SUBJECT: ARKANSAS NUCLEAR ONE, UNIT 2 (ANO-2) - RELAXATION REQUEST
FROM U.S. NUCLEAR REGULATORY COMMISSION (NRC) FIRST REVISED
ORDER EA-03-009 FOR THE CONTROL ELEMENT DRIVE MECHANISM
(CEDM) NOZZLES (TAC NO. MC2303)

SAFETY EVALUATION BY THE OFFICE OF NUCLEAR REACTOR REGULATION

RELAXATION REQUEST FROM FIRST REVISED ORDER EA-03-009

ARKANSAS NUCLEAR ONE UNIT 2

Figure 1

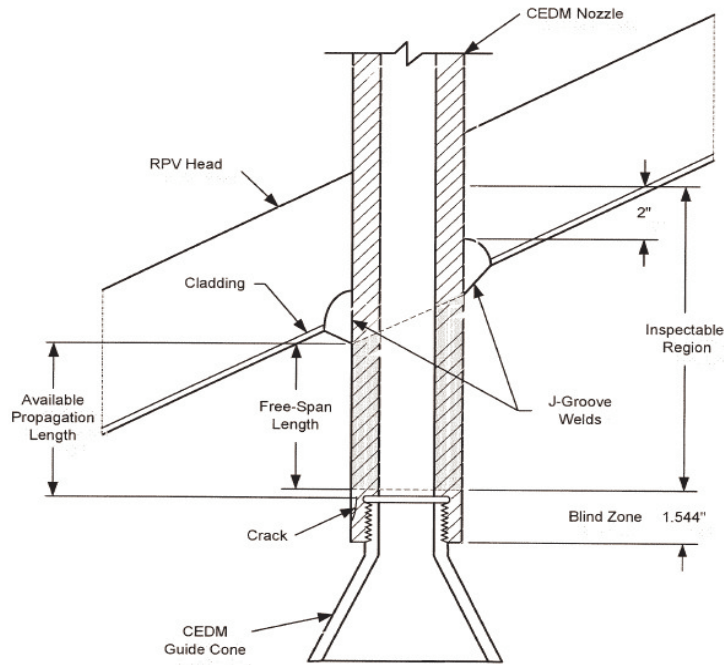
The licensee states that the ID surface of each CEDM nozzle (i.e., nozzle base material) shall be UT examined from two (2) inches above the J-weld to 1.544 inches above the bottom of the nozzle. The licensee will also perform an assessment to determine if leakage has occurred into the interference fit zone, as currently specified in Section IV.C.(5)(b)(I) of the First Revised Order. Figure 1 is from the licensee's submittal and shows the inspection areas of a CEDM nozzle as defined by the licensee.

The licensee states that meaningful UT data cannot be collected in the threaded area or the chamfer region. The chamfer region geometry causes sporadic signals while, once the guide cone is reached, sound cannot pass into the CEDM nozzle base material because of the gap that exists between the guide cone and the nozzle at the threaded connection. This leaves a

length of 1.344 inches ($1.25 + 0.094$) at the bottom of the CEDM nozzle that cannot be inspected by UT examination due to nozzle configuration.

The NRC staff concludes that the licensee's proposed alternative examination of the CEDM RPV head penetration nozzles using UT from 2 inches above the J-groove weld to 1.544 inches above the bottom of the CEDM nozzles, and the augmented examination of nozzles without sufficient free-span length for one cycle of postulated flaw growth, provide reasonable assurance of the structural integrity of the RPV head, vessel head penetration nozzles, and welds. Further, inspection of the CEDM nozzles in accordance with Section IV.C.(5)(b) of the First Revised Order EA-03-009 would result in hardship without a compensating increase in the level of quality and safety. Therefore, pursuant to Section IV, Paragraph F, of First Revised Order EA-03-009, good cause has been shown for relaxation of the Order, and the NRC staff authorizes, for one operating cycle commencing with the startup from the Spring 2005 refueling outage, the proposed alternative inspection for all CEDM head penetration nozzles at ANO-2, subject to the following condition as stated in the licensee's submittal dated March 11, 2004:
